# TECH-NIQUE

S-225

December 6, 1973

SUBJECT: CAP FREQUENCIES FOR COURIER TUBE AND TRANSISTOR  
UNITS (TRAVELLER AND CLASSIC)

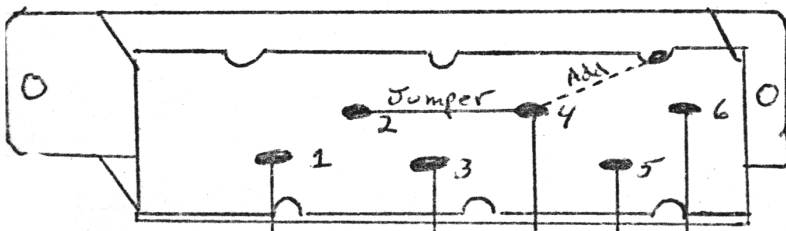
To improve treble response of receiver audio, remove the jumper  
wire inside microphone switch which connects pin #2 to #4. See  
drawing below. Add jumper from #4 to frame to assure no hum pickup.
